From: Brissette, Renee C.
Sent: Thursday, October 04, 2018 3:10 PM
To: 'Verlyn Miller'; Wolfenbarger, Jeanne; Carloss@sundancemech.com
Cc: Adeeb, Muhanned W; Rodriguez, Jason T.
Subject: RE: Hughes Family Warehouse on Beverly Hills

BEVERLY HILLS

1 Cut - 2 Piece BBRG Elbow Cut Sheet
 18"Ø / 2 1/2" Wall / CI-III / 22.5° RIGHT

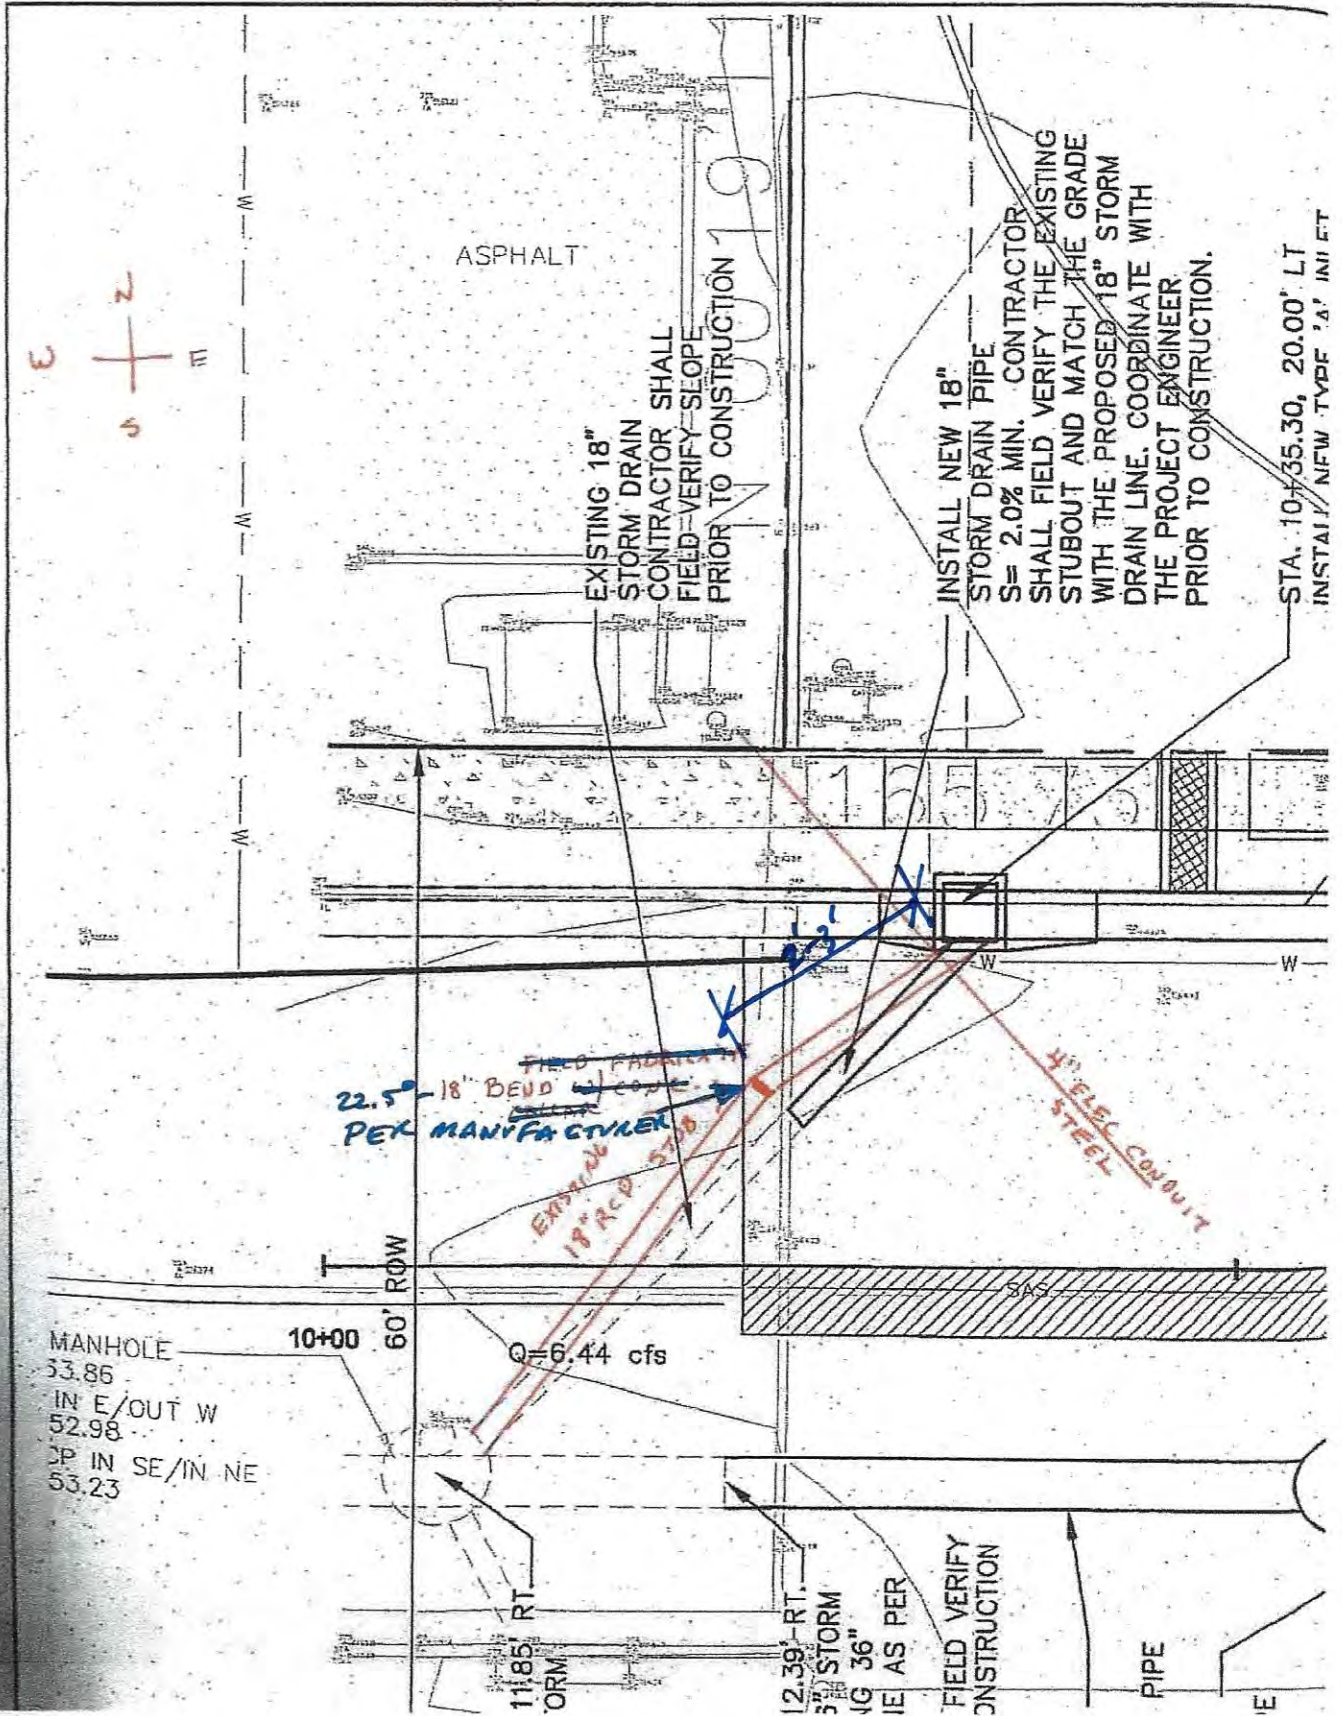
Attached is the proposed change by the contractor for a SD lateral that we discussed earlier and a picture showing the 4" steel casing that they are trying to avoid. We do not see any issues with hydraulic performance of the SD lateral given the peak flow anticipated at this inlet. Please let me know if the City concurs.

Attached is a photo of the Beverly Hills inlet conflict with the 4" steel conduit.

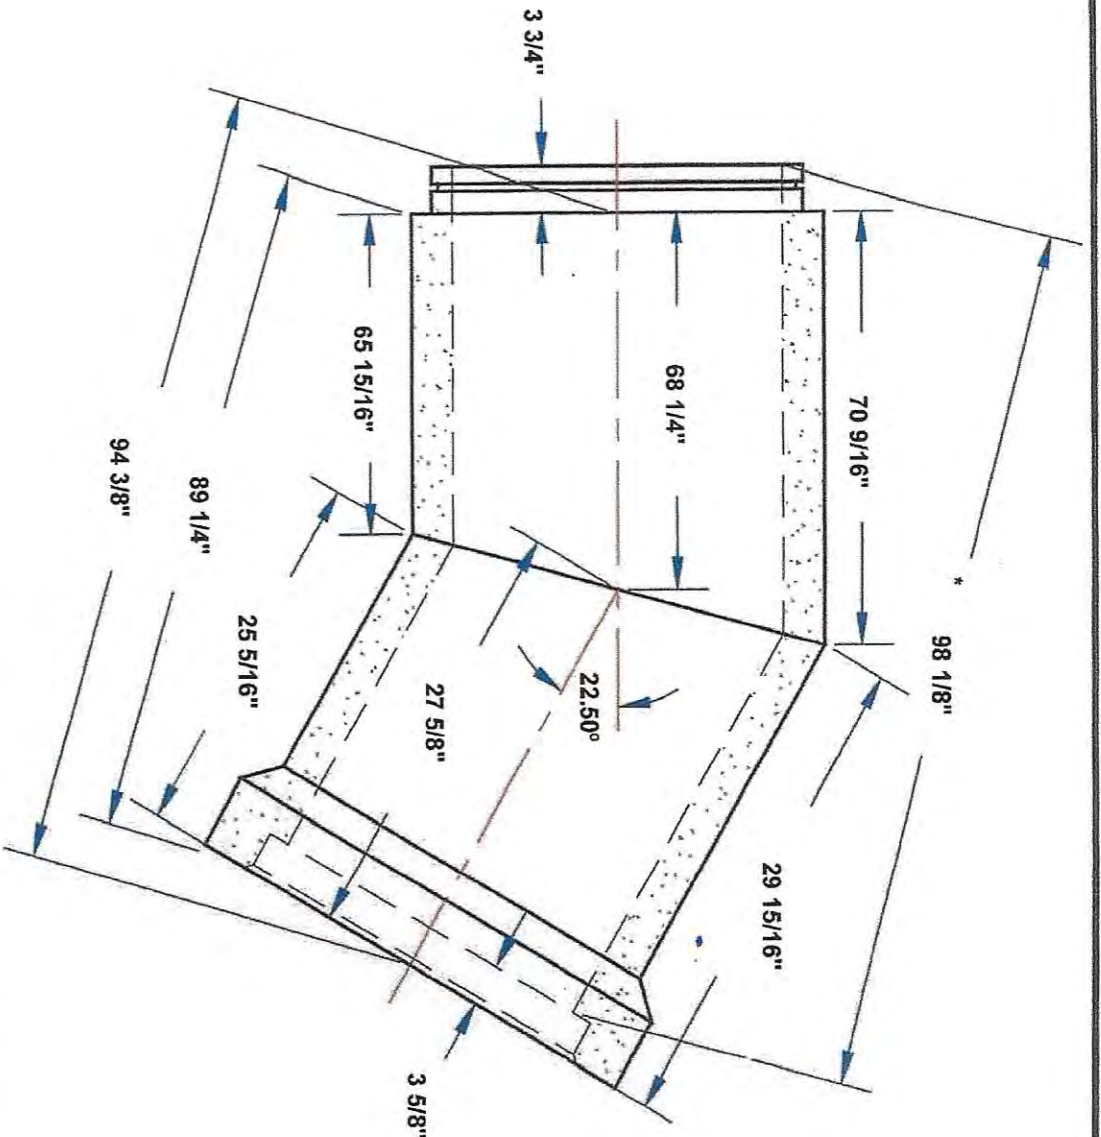
Attached is a revised sketch showing a dimension of 2-3 feet from the bend to the curb inlet.

Please put the distance from both the existing MH and the proposed inlet to the bend on the sketch. One of these access points must be within 3 feet of the bend. Also is what they installed this Rinker bend? It does not appear so in the construction photo. Please verify for me.

This email will serve as an approval from Hydrology for the provided storm sewer bend information. If you have a question, please give me a call.
